KEMPSEY DISTRICT HOSPITAL REDEVELOPMENT (SSD5363)

RESPONSE TO SUBMISSIONS REPORT

Project Status	Post-Exhibition	02	Revised as per HI comments	23.10.2013	
	RtS Director	AL				
	Checked by	AL				
	Date Issued	23 October 2013				
	Issue Type	For Minister's Determination				
	Proponent	<div><div></div><div>Health Infrastructure</div></div>

FIGURE 02: Site Plan - Proposed Works

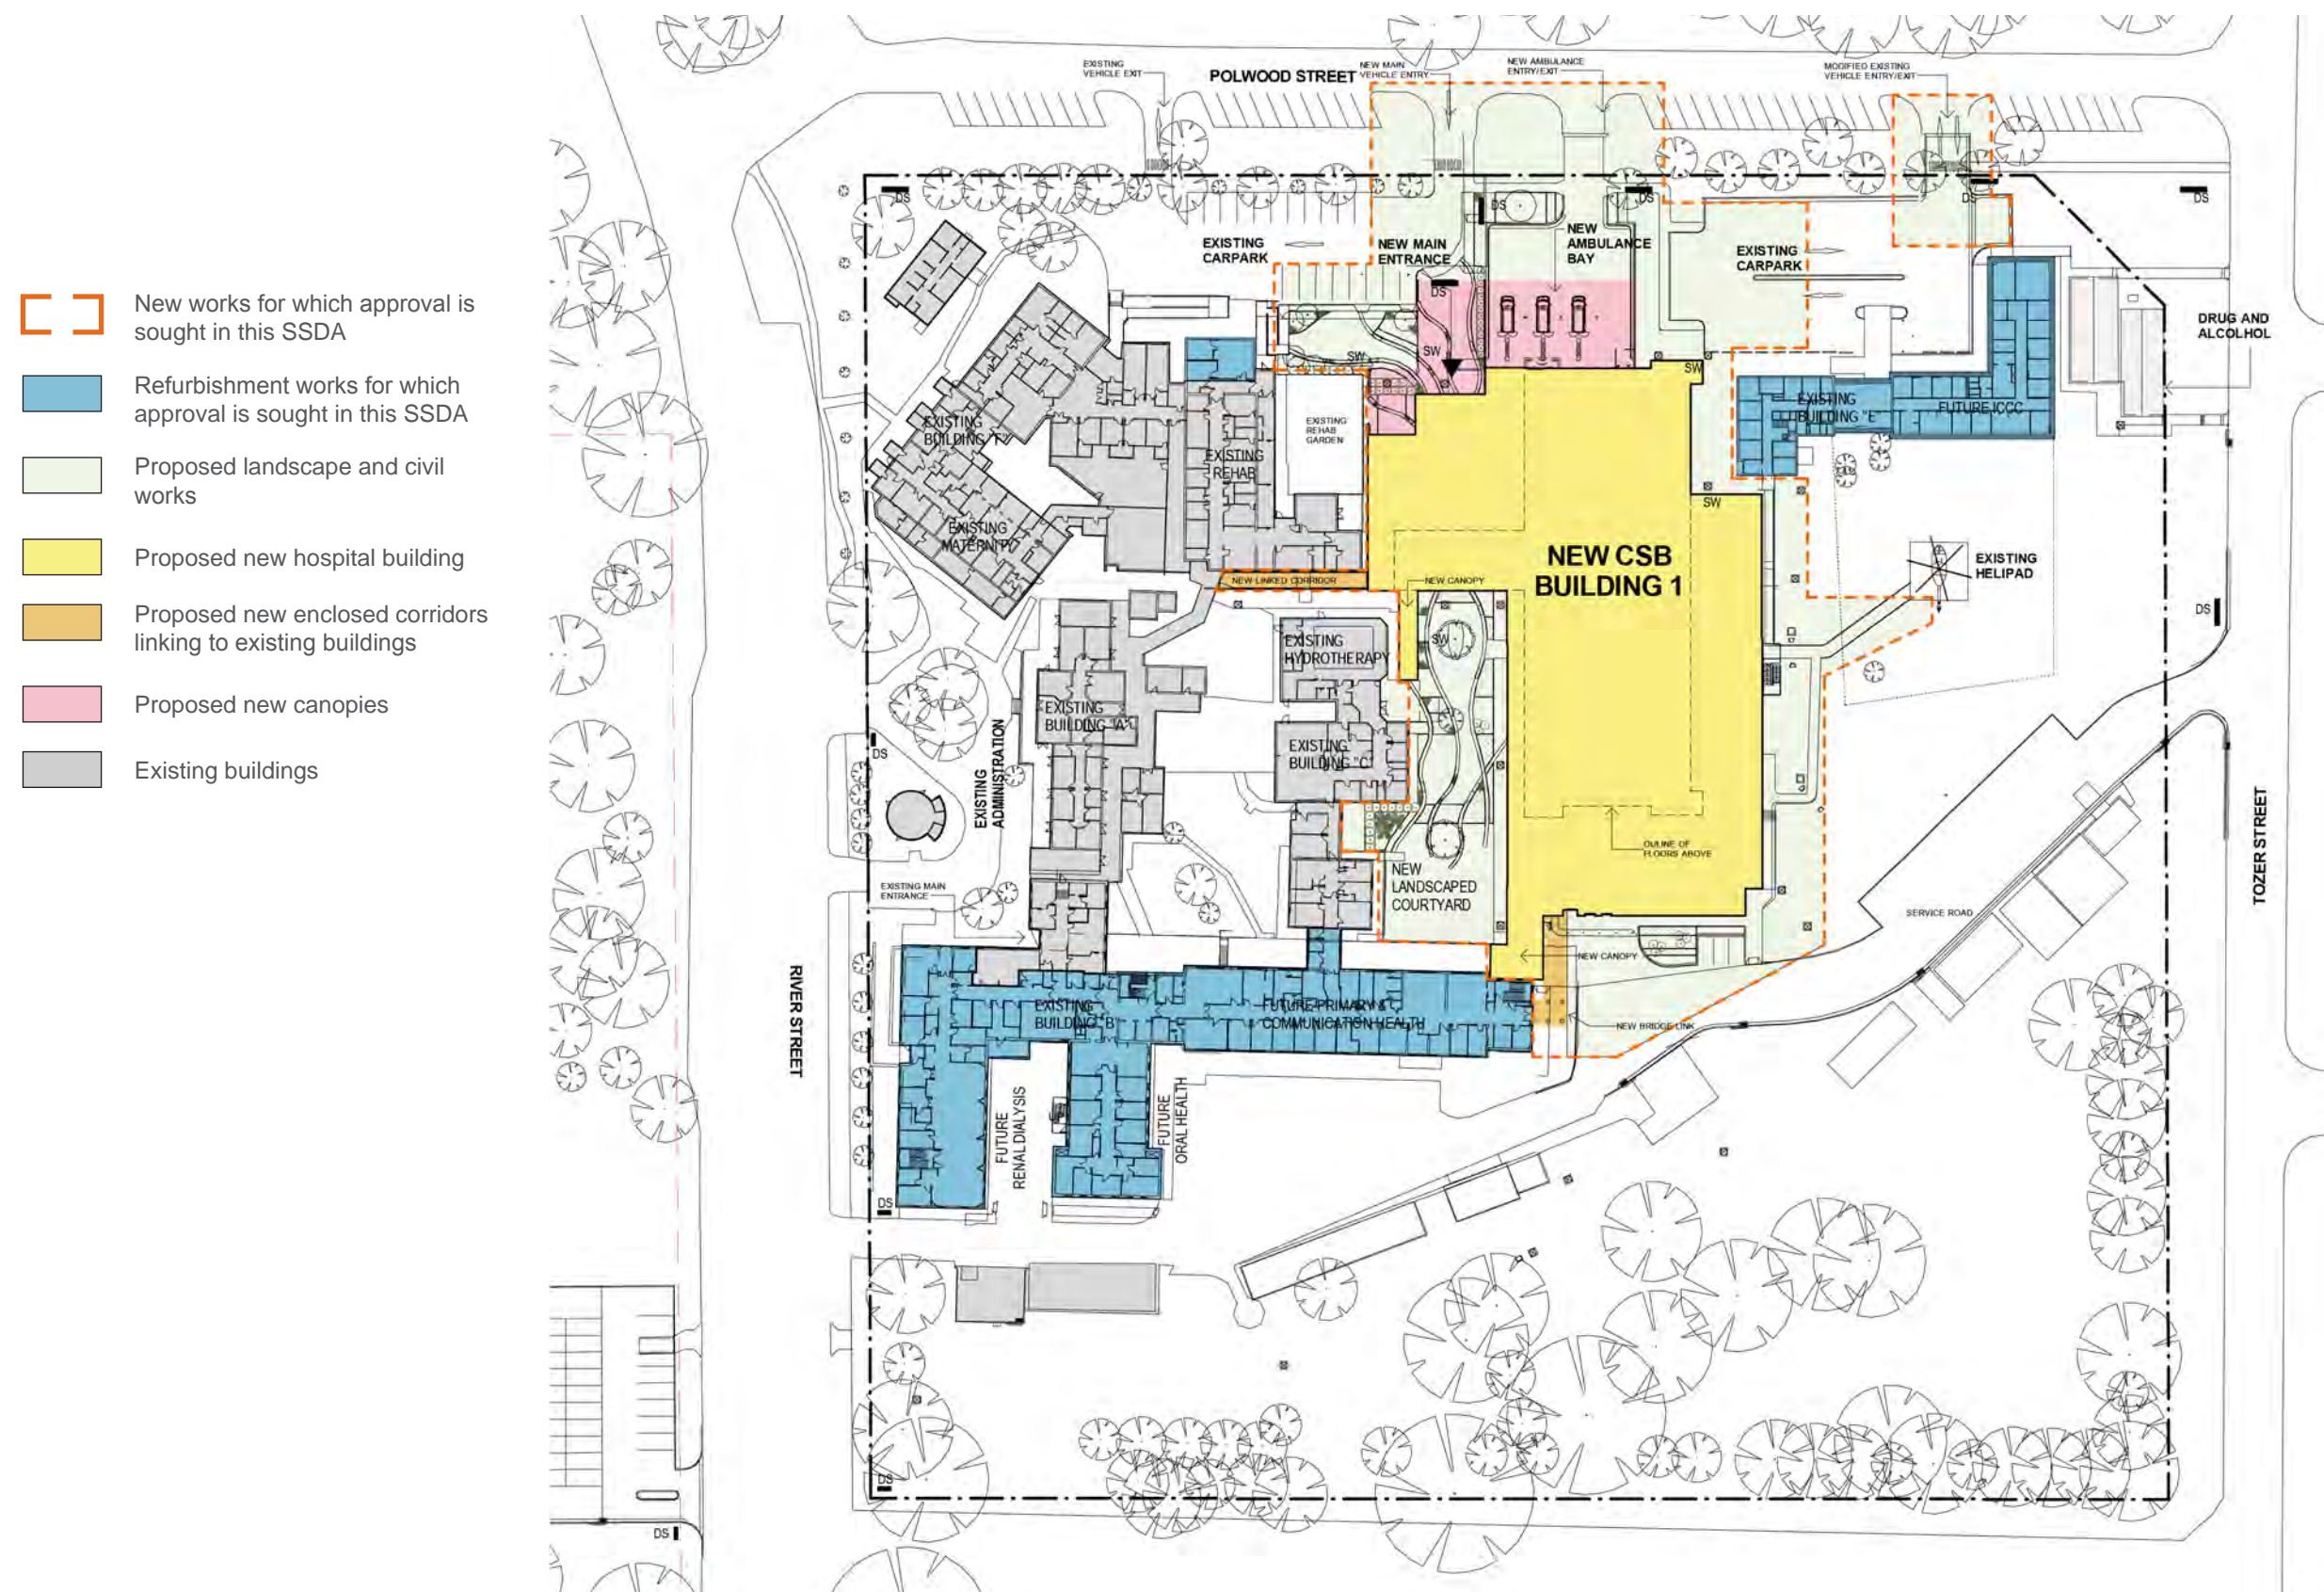
<ul style="list-style-type: none"> <i>Clarification regarding the extent of works forming part of the application (i.e. whether the proposed site works form part of the application) and, if so, incorporate details of the proposed works on the staging plan, relevant floor plan and landscaping plans.</i> 	<p>The extent of works forming part of the application is shown in Figure 2 and is included in the Appendix C.</p> <p>The staging plans provided in Appendix A of the Exhibited EIS indicate the various works to be undertaken on site and the approval strategy for each component. Refer to exhibited drawings:</p> <ul style="list-style-type: none"> 5027-BVN-AR-DWG-1DA-A11 5027-BVN-AR-DWG-1DA-A12 5027-BVN-AR-DWG-1DA-A13 5027-BVN-AR-DWG-1DA-A14 (It is note that this drawing is now superseded by Figure 2 / Drawing 5027-SKM-AR-DWGN1-B101 contained in Response to Submissions report).

DRAWING
SITE PLAN - PROPOSED

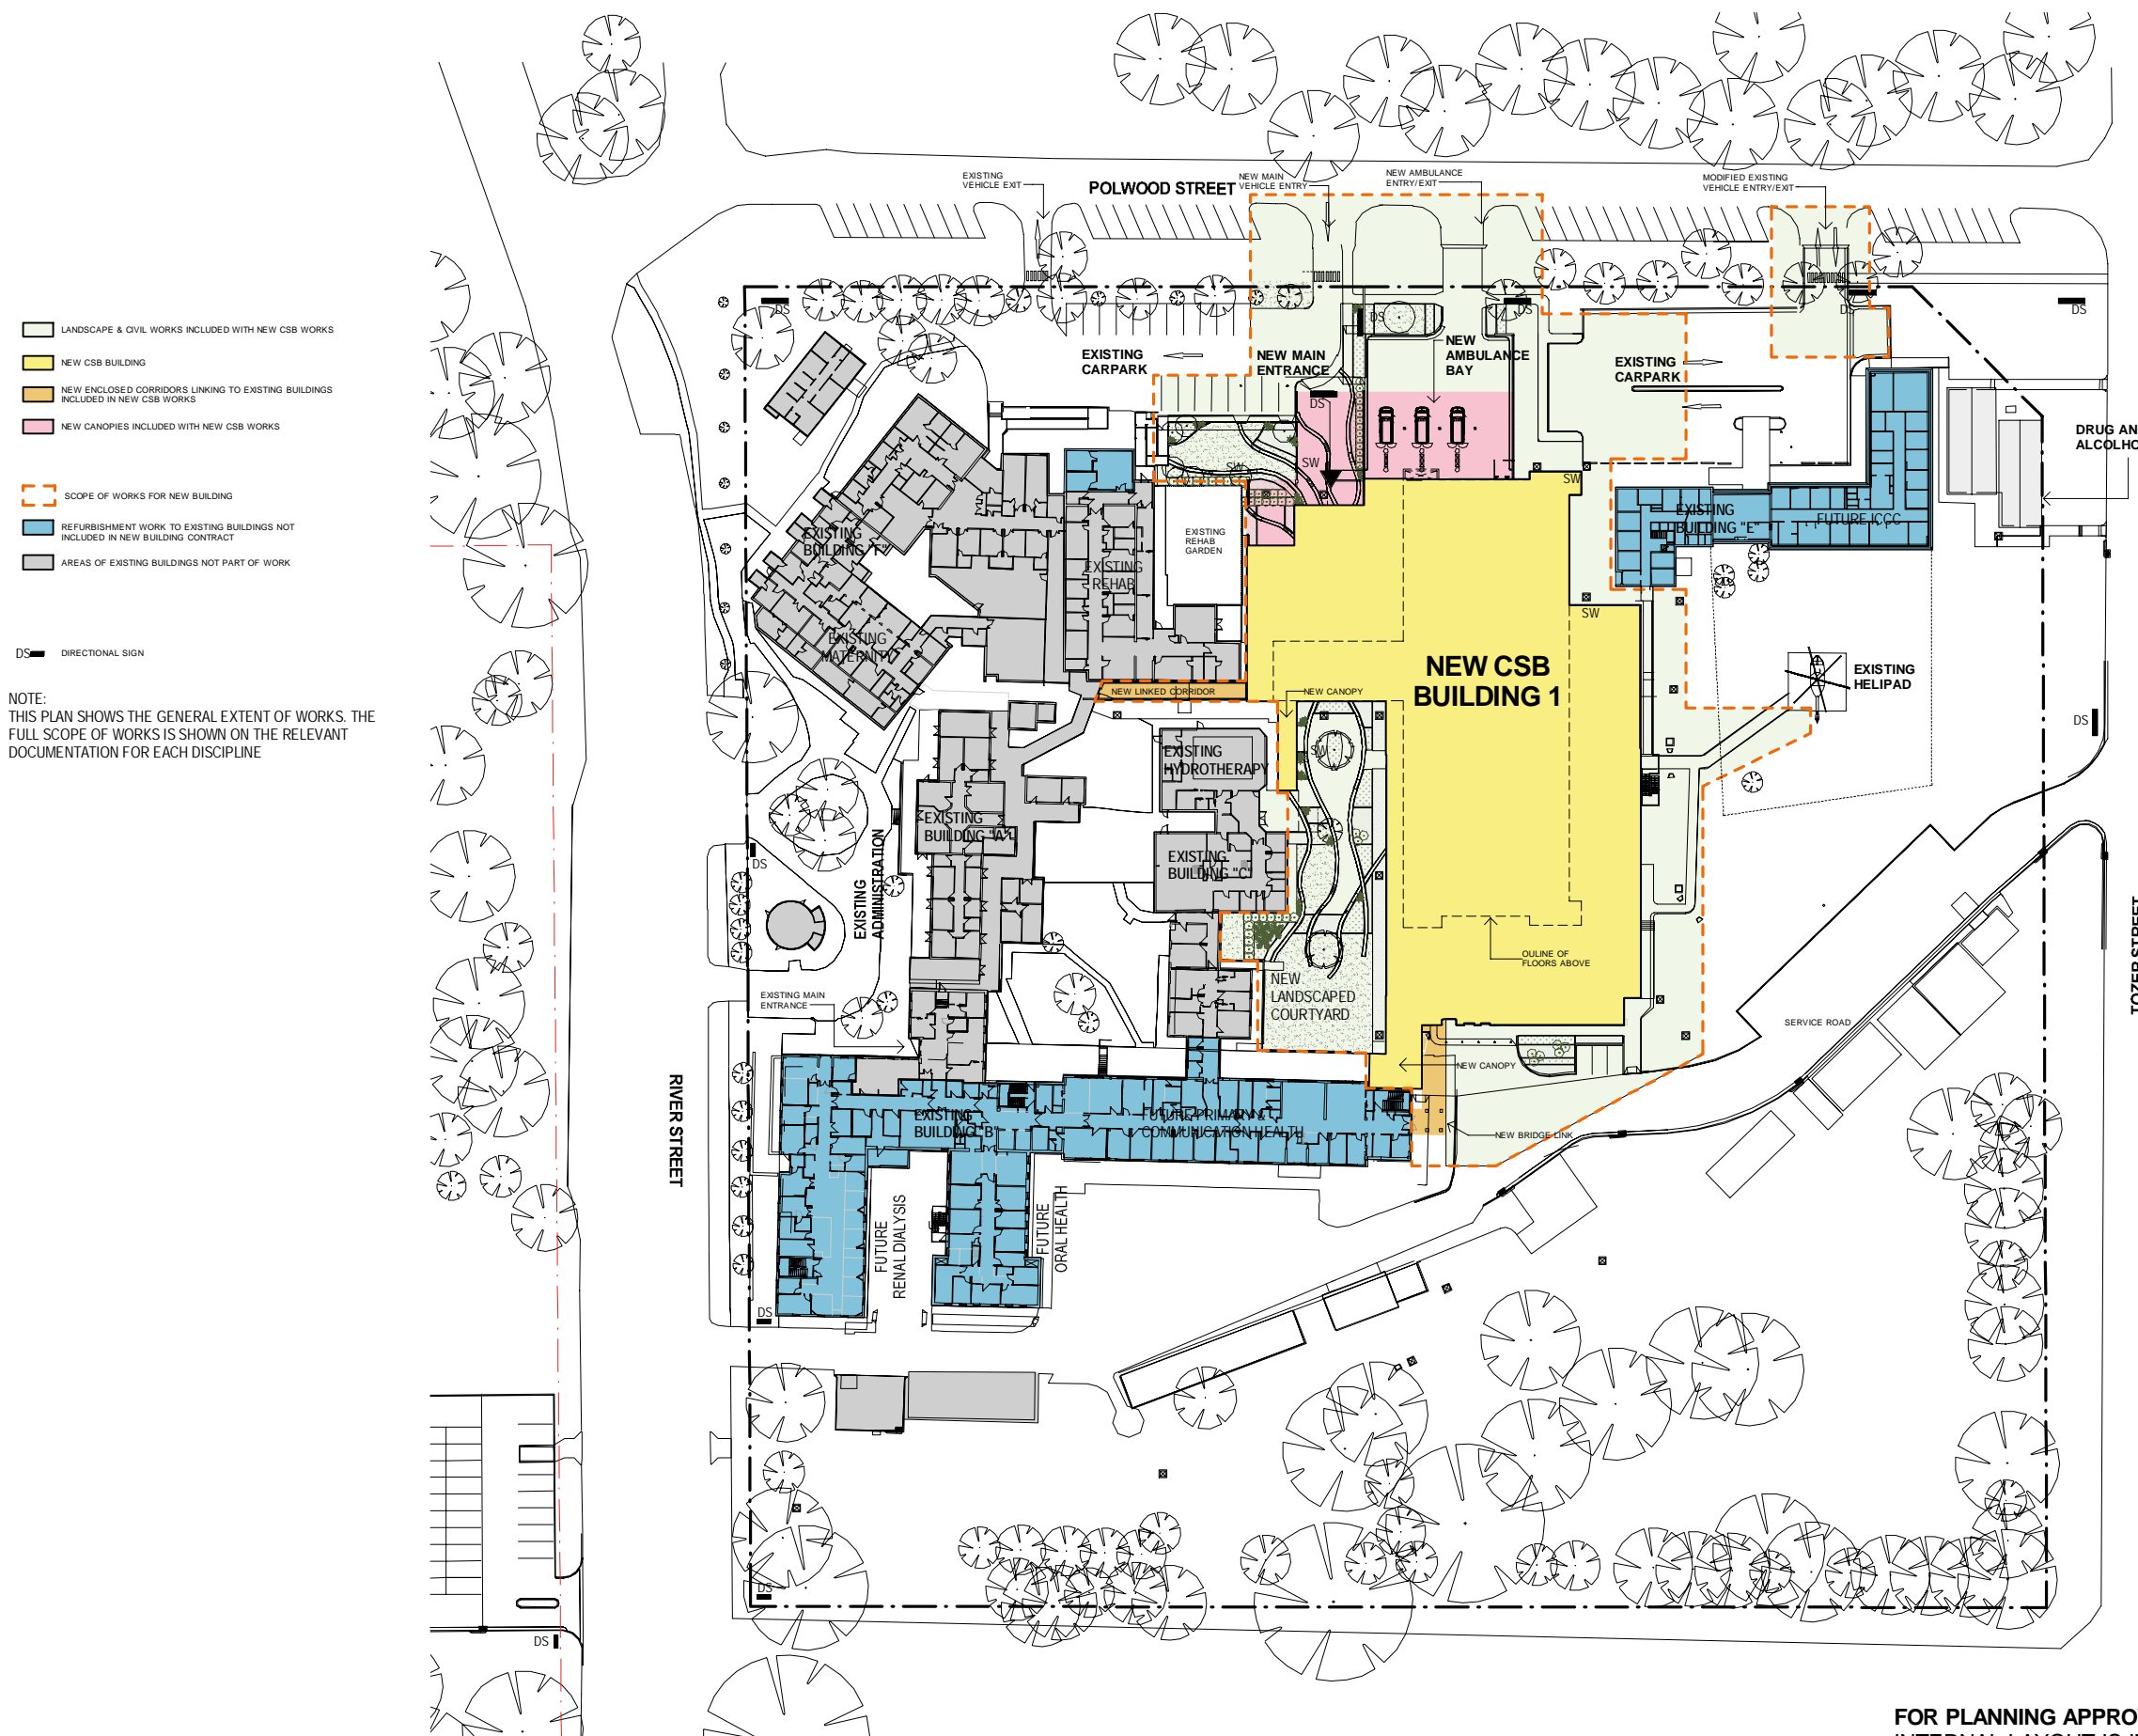
RECOMMENDED CONDITIONS	RESPONSE
<p>(1) <i>The development proposal is to comply with the layout identified on the drawing titled Site Plan - Proposed, prepared by BVN Donovan Hill, reference Drawing No. 5027-BVN-AR-DWG-1 DA-A01 .</i></p>	<p>It is noted that the relevant drawing has been revised. Please refer to Section 4.0 of this report and Appendix C.</p>
<p>Asset Protection Zones</p> <p><i>The intent of measures is to provide sufficient space for fire fighters and other emergency services personnel, ensuring radiant heat levels permit operations under critical conditions of radiant heat, smoke and embers, while supporting or evacuating occupants. To achieve this, the following conditions shall apply:</i></p> <p>(2) <i>At the commencement of building works and in perpetuity the entire site of the proposed Hospital redevelopment shall be managed as an inner protection area (IPA) as outlined within section 4.1.3 and Appendix 5 of ‘Planning for Bush Fire Protection 2006’ and the NSW Rural Fire Service’s document ‘Standards for asset protection zones’.</i></p> <p>(3) <i>Landscaping of the site shall comply with the principles of Appendix 5 of ‘Planning for Bush Fire Protection 2006’.</i></p>	<p>Agreed.</p>

1. The development proposal is to comply with the layout identified on the drawing titled Site Plan – Proposed, prepared by BVN Donovan Hill, reference Drawing No. 5027-BVN-AR-DWG-1DA-A01.
